AGENDA

DEVELOPMENT DETERMINATION PANEL MEETING

3 Florence Avenue Collaroy - Modification of Consent to DA2015/0393 granted for demolition works and construction of a dwelling house and swimming pool

APPLICATION FOR MODIFICATION ASSESSMENT REPORT

Drawing: **SECTION 96**
ELEVATIONS

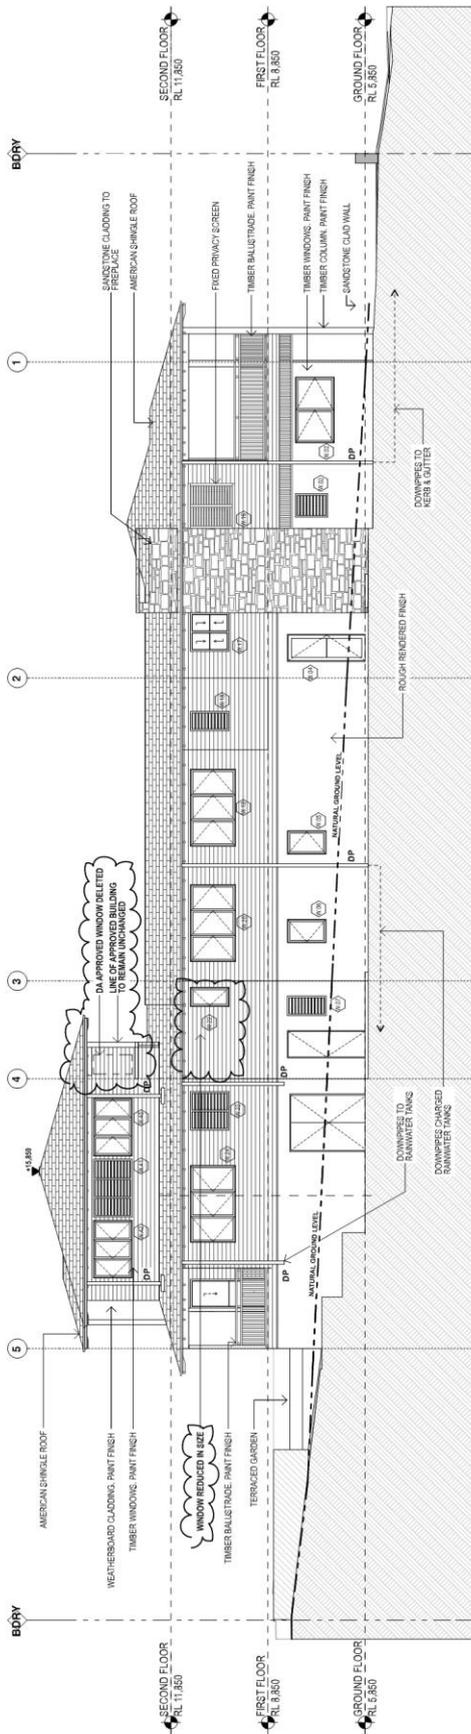
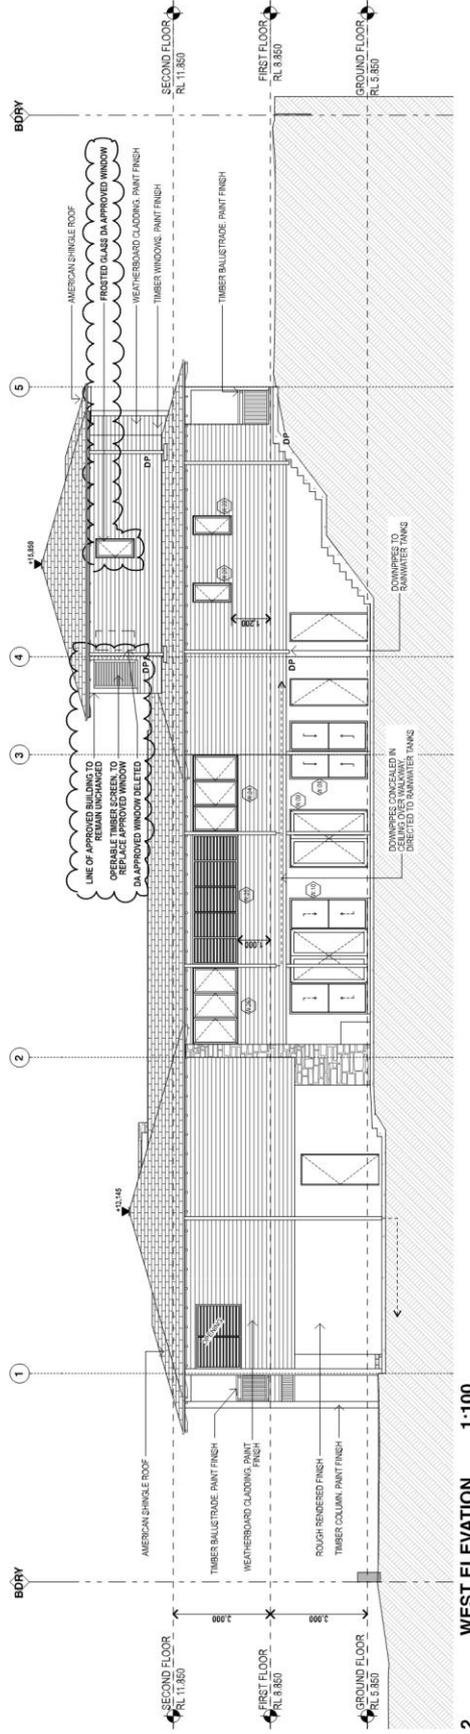
The element that does not comply is situated at towards the rear of the dwelling, and will not be readily visible from any public area. The 200mm increase in height of the wall will not significantly alter the overall size and scale of the dwelling, and makes a very minor visual difference when viewed from adjoining properties compared to the original approval. The overall height of the building does not change, and the development is considered acceptable in this regard.

Concerns were raised regarding view loss from unit 5, at 7 Ocean Grove to the rear of the subject site. The views affected are water views. The view encompasses Narrabeen Beach and Headland, and the headlands further to the North. The part of the view to be affected from Unit 5 is across the subject site and between the existing dwellings at 6 and 8 Florence Avenue. The part affected by the modifications is only a very small part of the overall view, is a small part of extra water compared to the original approval, due to the raised wall height and lowered pitch of the roof.

The overall ridge height of the development remains unchanged. The wall height has been increased by 200mm, and the pitch of the upper level roof reduced, so that the roof line will take away a small amount of extra water view on each side of the dwelling, but will not impact on any of the most significant features of the view such as the headlands to the north. This small amount of extra view disruption does not have any significant impact on the view as a whole (compared to the original approval), and the proposed view loss caused by the modifications is considered to be negligible in the context of these principles.

A 1.8 metre privacy screen (measured from finished floor level) is to be erected on the outermost eastern edge of the deck located off the first floor living room as shown on the approved plans. The screen is to extend from the northern end of the eastern wall of the living room to the 6.5m front setback line shown on the approved plans.
